Energy - Docket Optical System

**California Energy Commission 2014 Appliance Efficiency pre-ruling
Comments of AccurIC Ltd, via docket number 14-AAER-1 in relation
to the proposed Voluntary California Quality LED Lamp
Specification**

Submitted by: Dave Bannister, CEO, AccurIC Ltd

On: 5th January, 2015

Figure 1: Proposed maximum LED flicker mask, for limiting biological effects (currently under consideration by IEEE Working Group PAR1789)

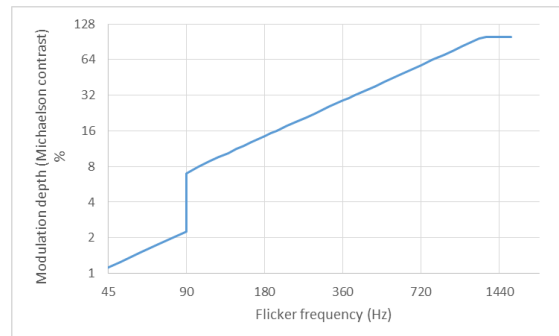
In view of both the multiplicity of mechanisms by which flicker can be generated and the sensitivity of a significant proportion of the population to flicker frequencies up to a few kilo-Hertz, it is necessary to establish and define maximum levels of flicker versus frequency in a manner similar to that used in defining EMC/EMI limits in electrical and electronic appliances. Namely, by constructing a ‘mask’ which defines these maximum levels and by defining a practicable filter-based test method by which the light output of an LED lamp can be tested against the mask. Defining such a mask has been the central focus of the work carried out by the IEEE PAR1789 Working Group on LED flicker. Figure 1 shows the general construction of the mask that defines the proposed upper-limit of flicker percentage, versus flicker frequency,

We strongly suggest, in order for a flicker performance related standard for LED lighting in the state of California to be aligned with emerging recommendations, based on peer-reviewed research, that the maximum flicker mask shown in Figure 1 should be used as the basis for such a standard.

Figure 3: The construction of Low Pass Filter bands which, when used additively (see Table 1) provide a stepwise approximation (red line) to the draft IEEE PAR1789 maximum flicker mask

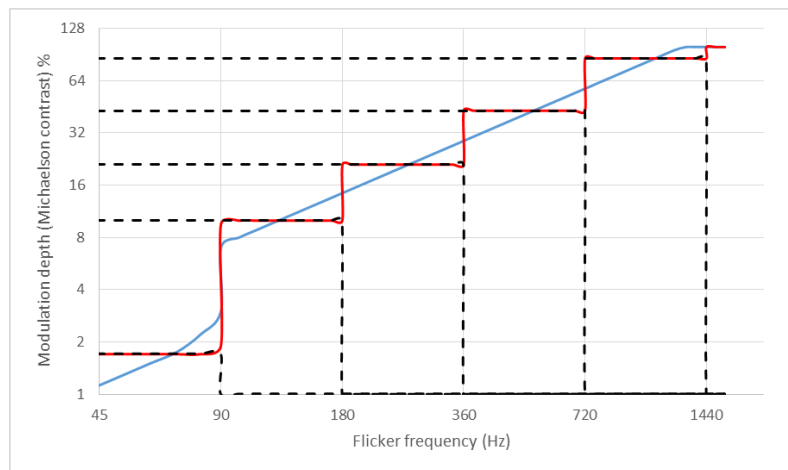
By choosing the cut-off frequencies of the low pass filters used in step 3(b) to be 90, 180, 360, 720 and 1440 Hz and defining appropriate maximum levels of modulation depth for each filter band, a stepwise approximation to the mask shown in figure 1 can be constructed. Figure 3 shows the low pass filter bands (shown as dotted lines) and the stepwise approximation to the mask (shown in red). The resulting flicker performance criteria, all of which need to be met in order to provide a sufficiently low flicker performance across all flicker frequencies, are summarised in Table 1.

Note: In order to ensure alignment with the proposed dimmability specification, the maximum flicker (modulation depth) criteria given in Table 1 should be met at the following dimming levels: 100% (undimmed) 50%, 20% and 10%
